2023MY
Sportage (NQ5, NQ5a)
w/Theta III 2.5L GDI

259 (Rev 1, 11/6/2025)

TECHNICAL SERVICE BULLETIN

LOGIC IMPROVEMENT (CA2509)

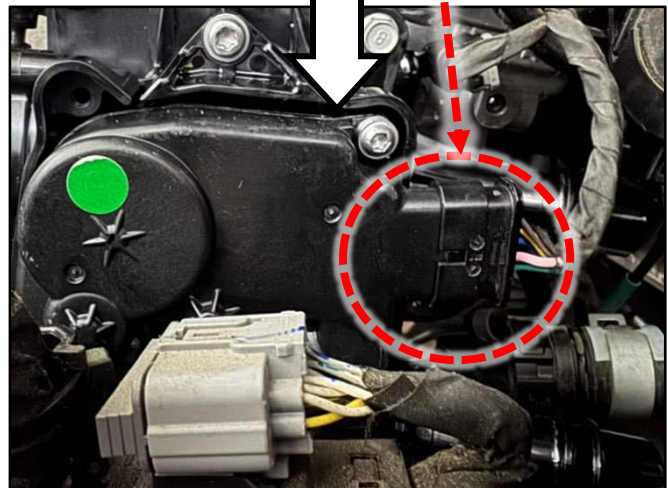
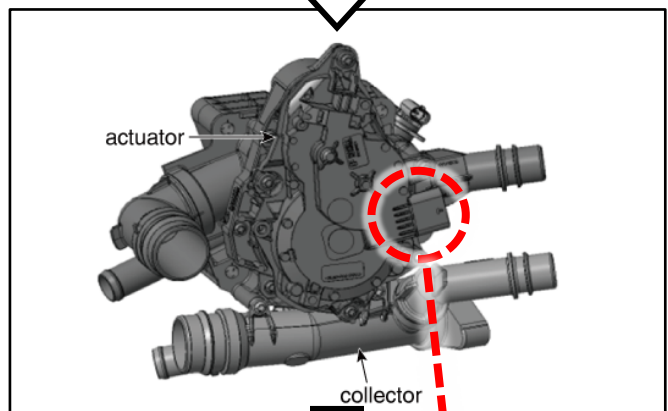
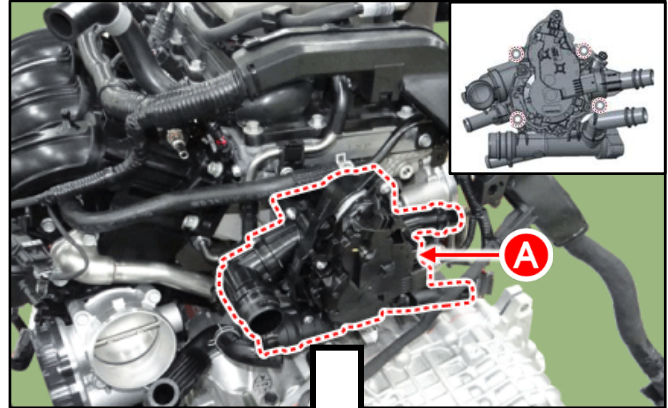
1. Replace the Integrated Thermal Management Module 'ITM' (A) by referring to "Engine Mechanical System → Cooling System → Integrated Thermal Management Module (ITM) → Repair procedures" in the applicable Shop Manual on KGIS.

Tightening torque for bolts:
7.2 - 8.7 lb.ft (9.8 - 11.8 N.m)

Do NOT disassemble the actuator and collector. The new ITM is supplied as an assembly unit.

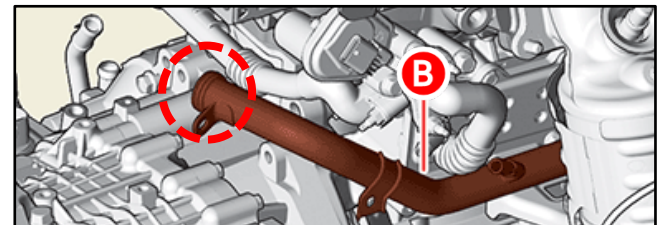
Note: The ITM connection orientation changes after replacing the new ITM part. The locking tab will face the engine.

Trying to make the connection on the new ITM in the same orientation as the original ITM may damage the connector pins/terminals.

3. Install a new inlet pipe (B) O-ring on the red circled area shown.
4. Proceed to upgrade the 'ECM' with Event 854 software in **Manual Mode** only, after ITM part replacement is completed by referring to the ROM ID tables on pages 3-5.
